DESIGN PH	DRAWN BY B	DART AEROSPACE LTD HAWKESBURY, ONTARIO, CANADA	
CHECKED #	APPROVED #	DRAWING NO. DSI 9346	REV. D SHEET 1 OF 1
DATE 07.07.24		TITLE DEVIATION ON D206-667	SCALE NTS
A	06.08.08	NEW ISSUE	
B	06.10.10	ADD B28679, B28682, B28683	
C	06.11.20	ADD B29261	
D	07.07.24	ADD B32664

DART SERVICE INSTRUCTION

TO AMEND INSTALLATION INSTRUCTIONS IIN-D206-667 REV. C

FIGURE 1 – INSTALLATION OF DART CROSSTUBES ON BHT/AAI SKIDTUBE

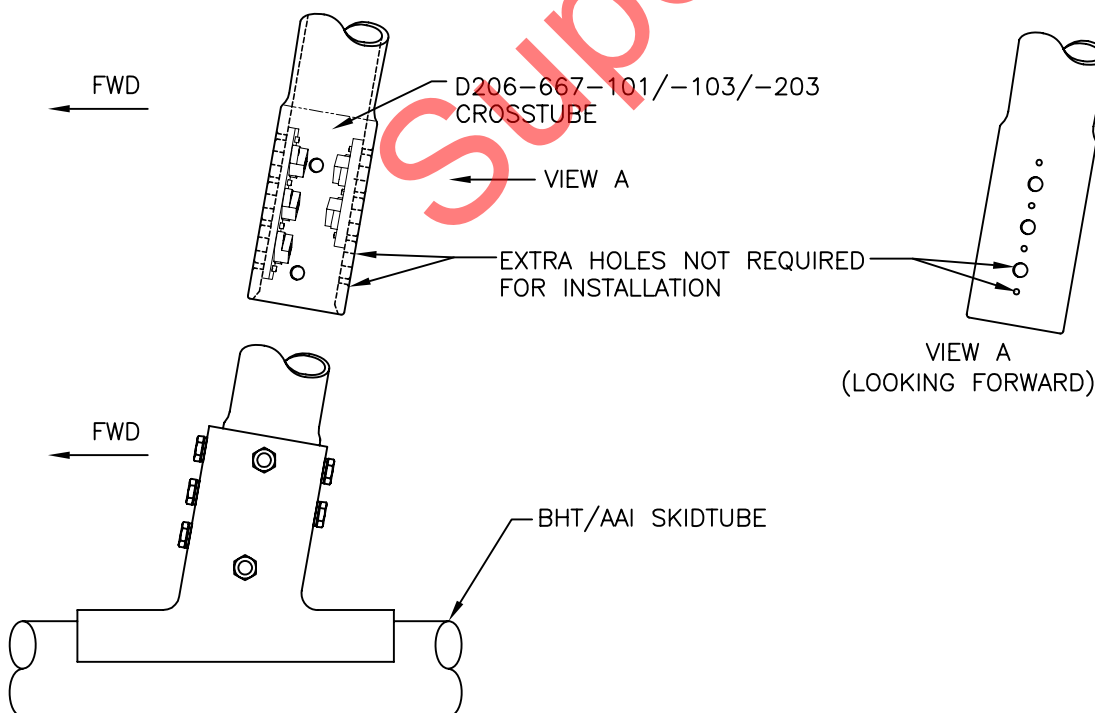
THE FOLLOWING D206-667-101/-103/-203 CROSSTUBES HAVE EXTRA HOLES DRILLED ON THE AFT SIDE OF THE CUFFS. THIS HOLE IS NOT REQUIRED FOR INSTALLATION OF DART CROSSTUBES ONTO BHT/AAI SKIDTUBES AS SHOWN IN FIGURE 1.

CUSTOMERS RECEIVING CROSSTUBES AT CHG 002 PRIOR TO 06.08.08 SHOULD CONTACT DART FOR DISPOSITION IF INSTALLING THE DART CROSSTUBES ONTO BHT/AAI SKIDTUBES PER IIN-D206-667 REV. C.

CUSTOMERS RECEIVING CROSSTUBES AT CHG 002 PRIOR TO 06.08.08 TO BE INSTALLED WITH DART SKIDTUBES MAY FIND THAT THE SUPPORTS HAVE BEEN INSTALLED BACKWARDS. THE SUPPORTS SHOULD BE REMOVED AND RE-INSTALLED PER ICA-D206-667.
